INDEX OF STRUCTURAL DRAWINGS

**KUHIO HIGHWAY SHORT-TERM
IMPROVEMENTS KUAMOO ROAD
TO TEMPORARY KAPAA BYPASS ROAD**
Fed. Aid Proj. No. NH-056-1(50)

"AS-BUILT"

LEGEND FOR AS-BUILT POSTINGS

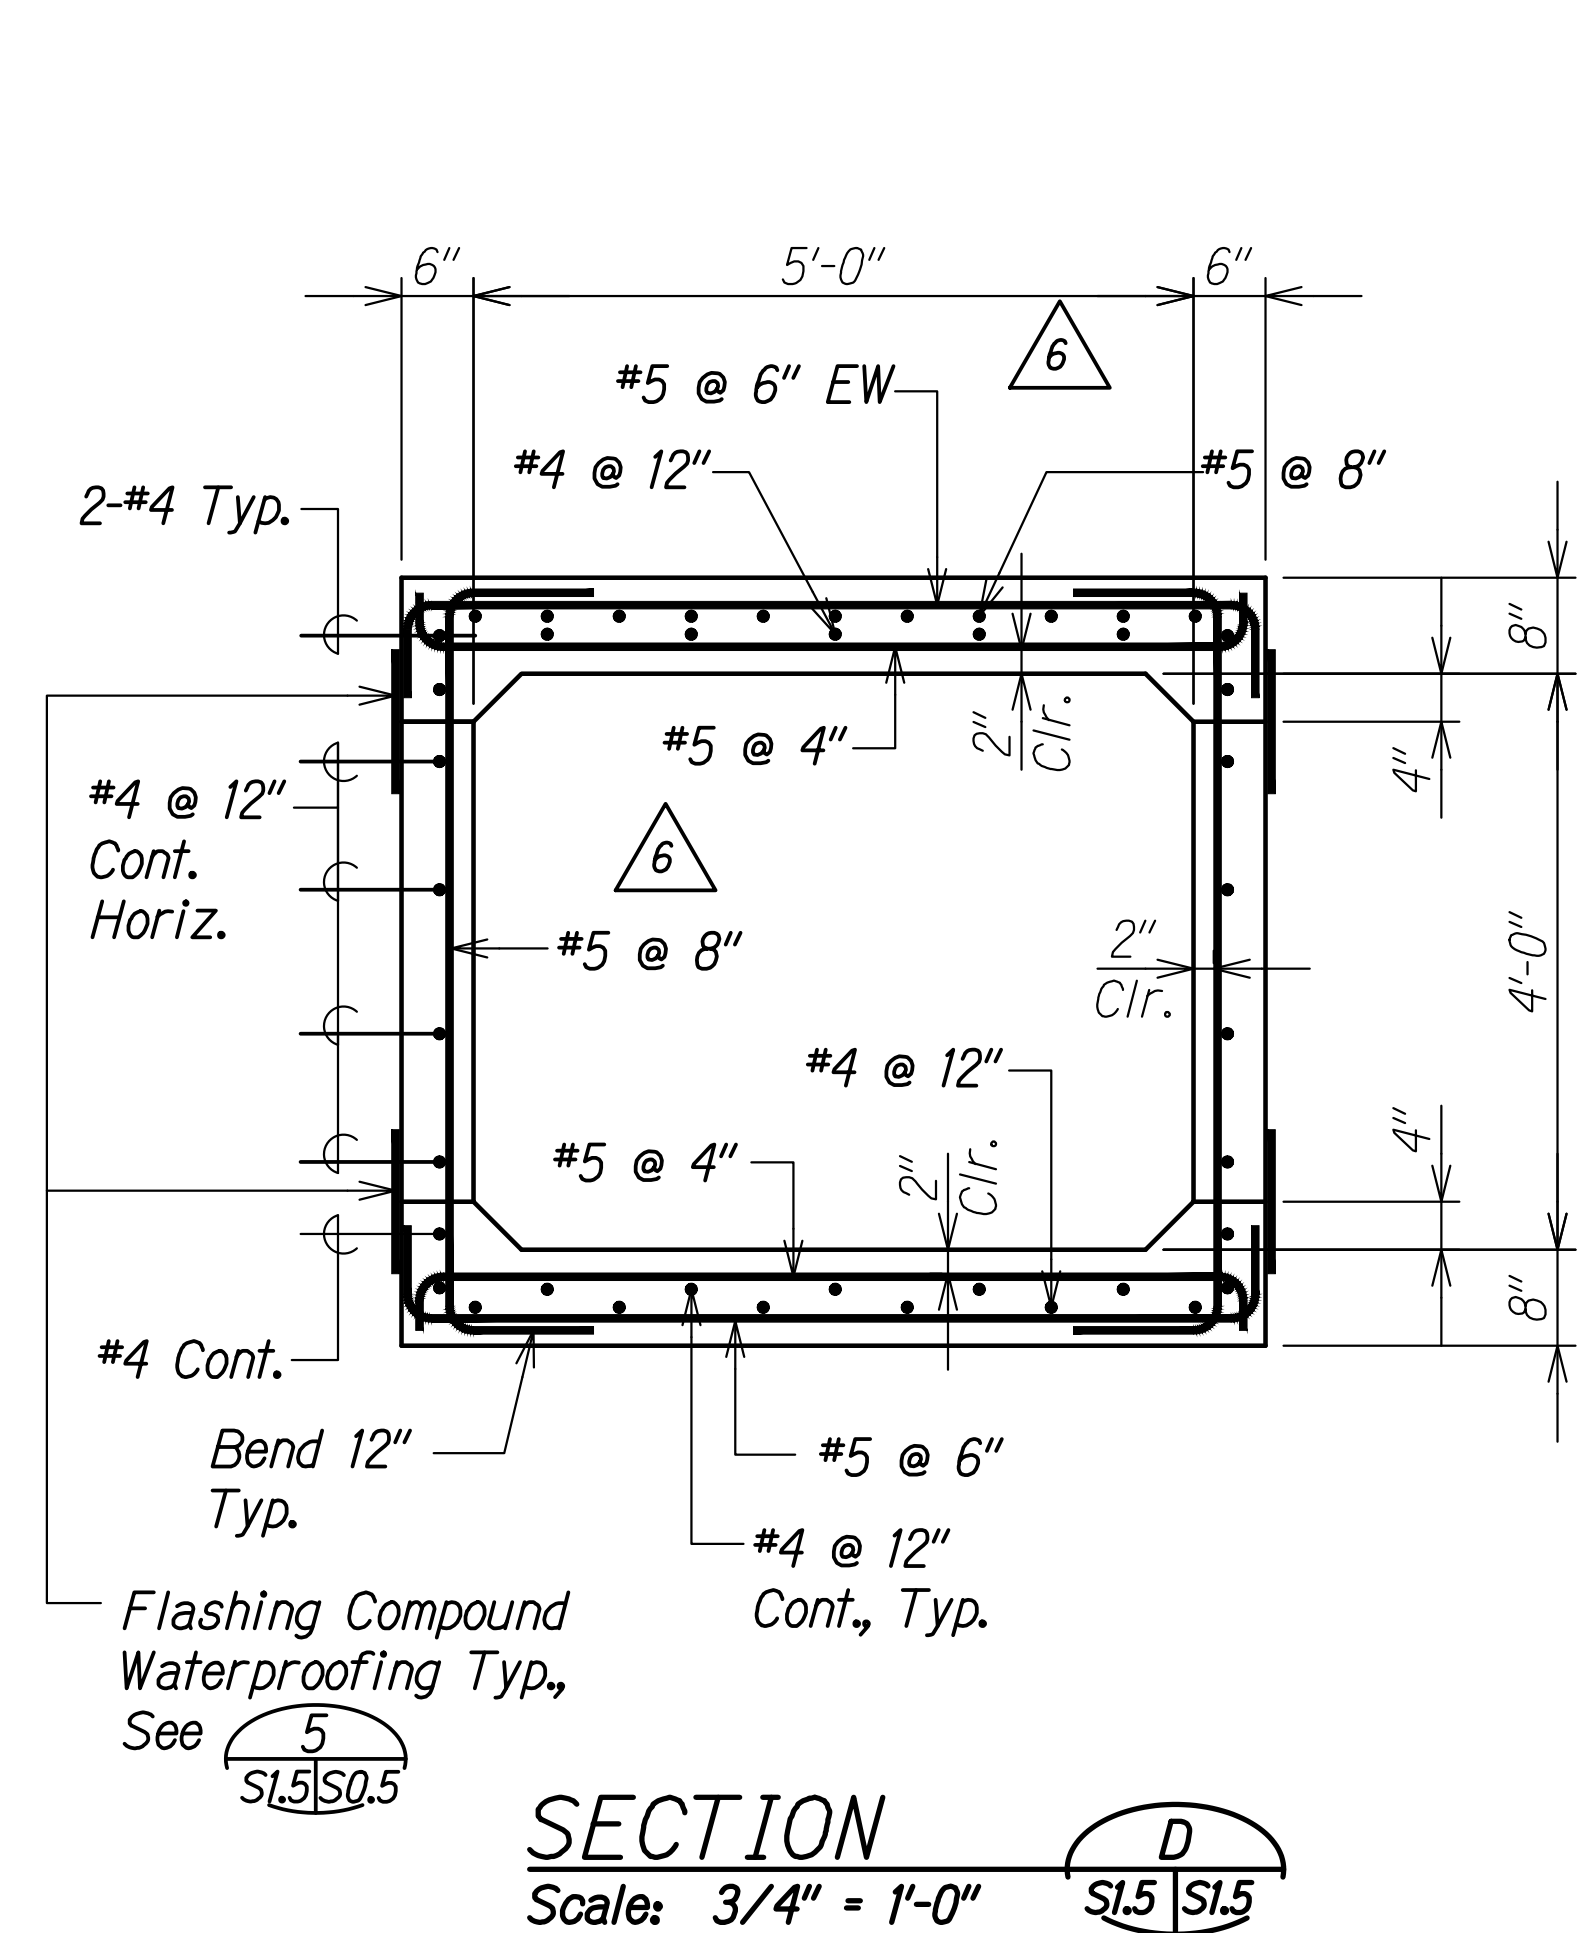
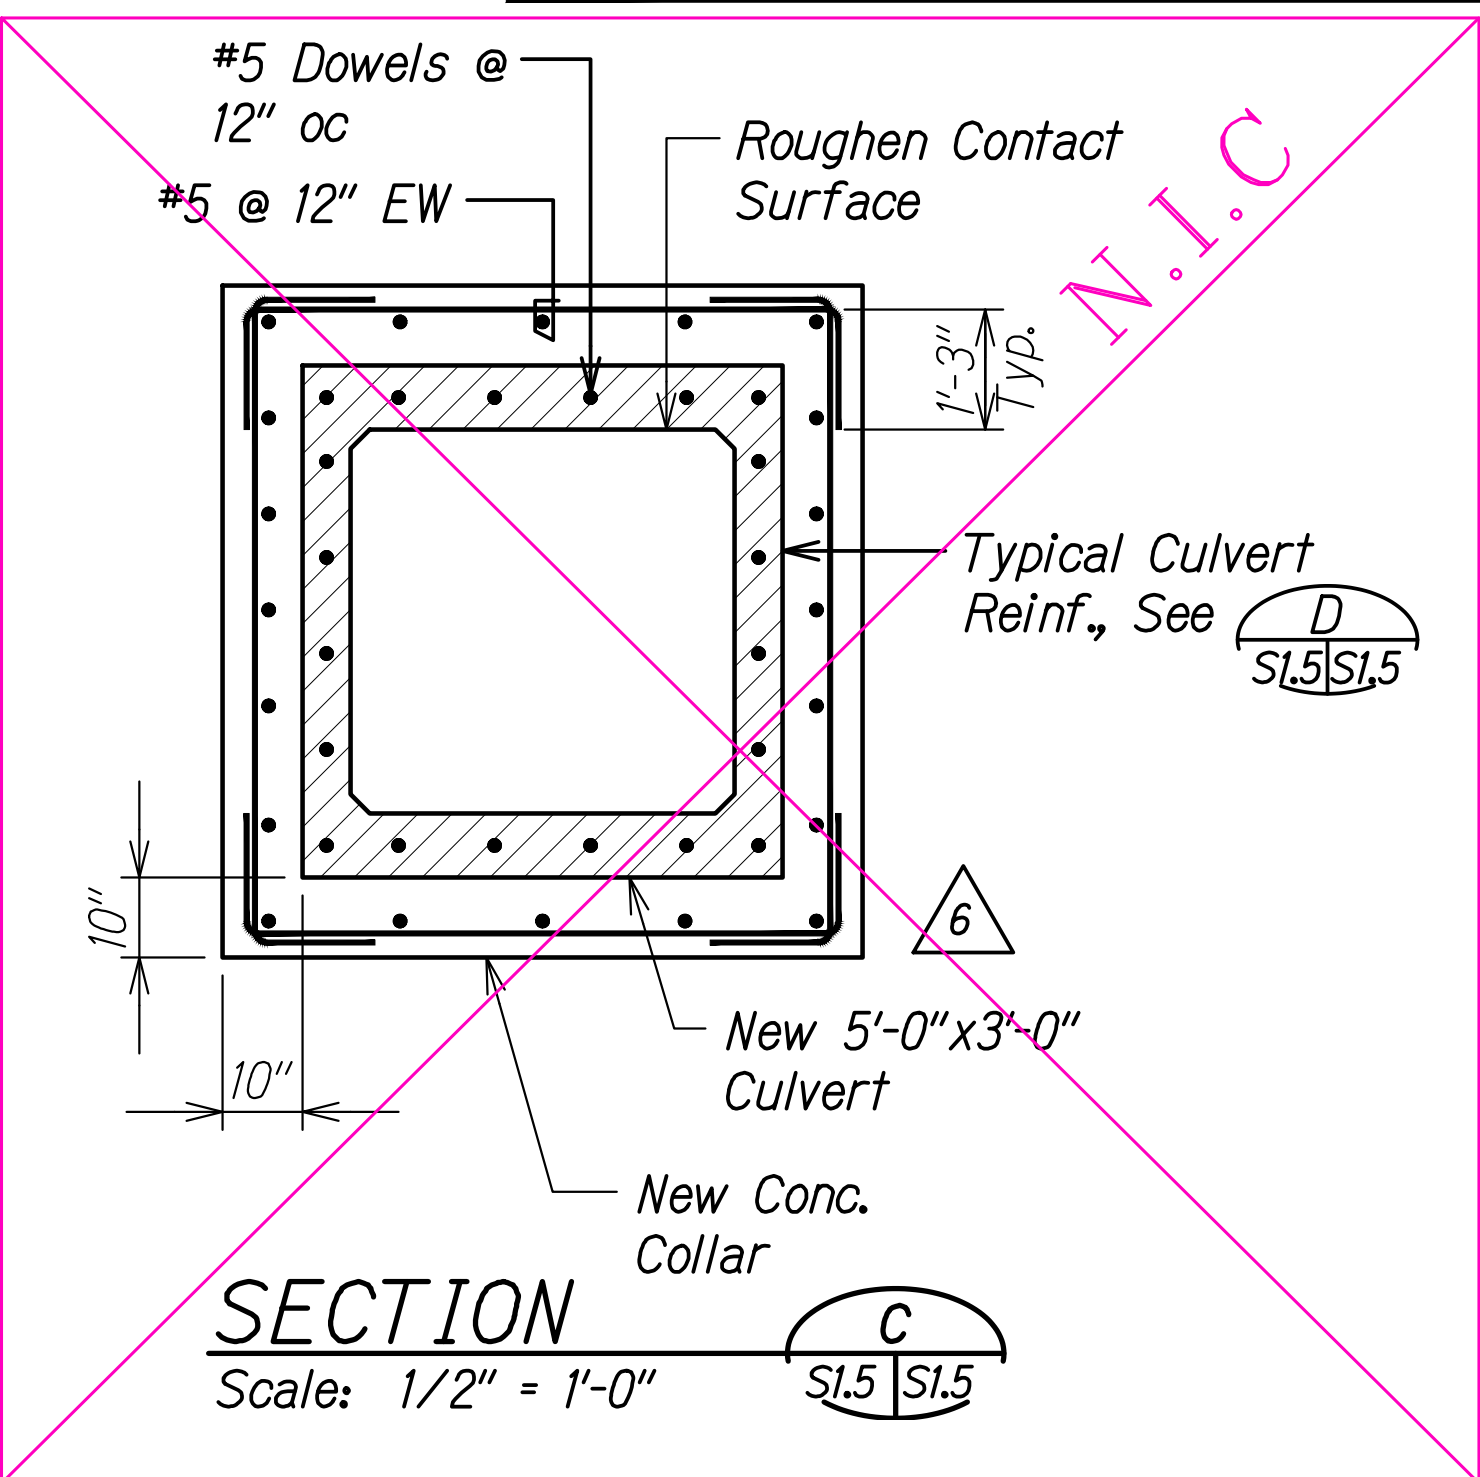
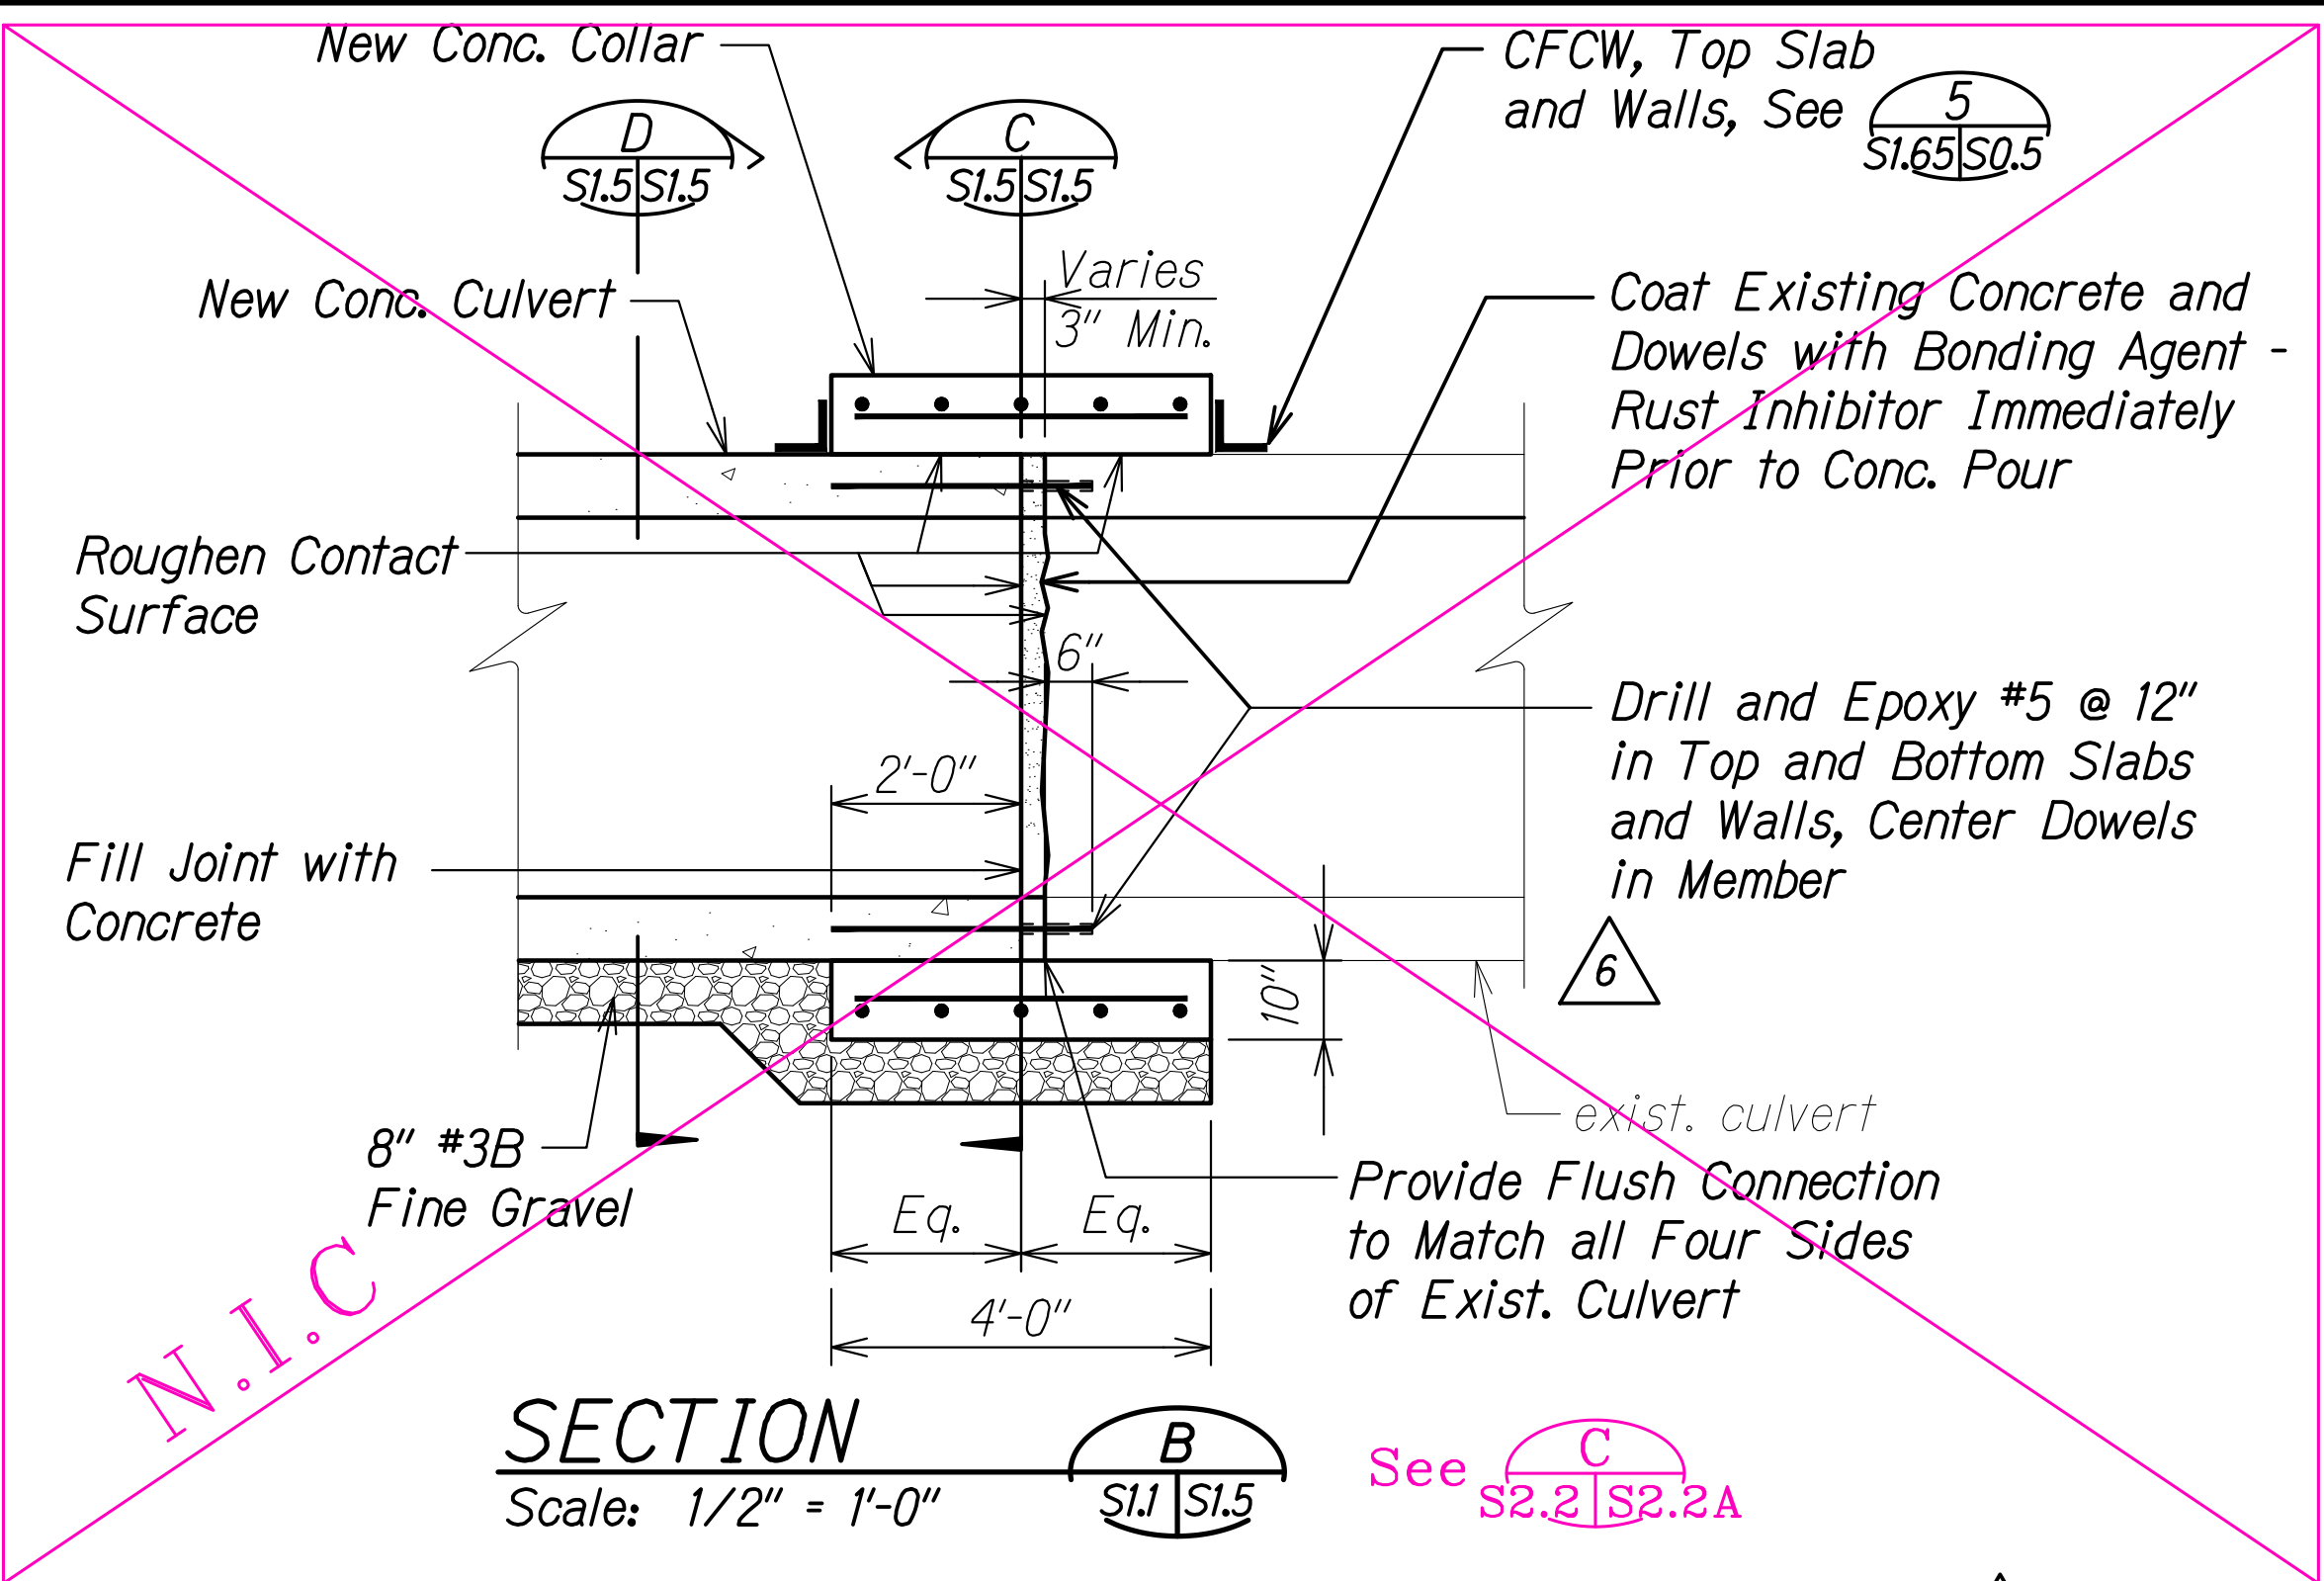
| DATE | REVISION |
|----------|---|
| 7/12/21 | 6 C.O. Revised headwall sections. |
| 7/5/21 | 5 C.O. Revised and new EB headwall sections. |
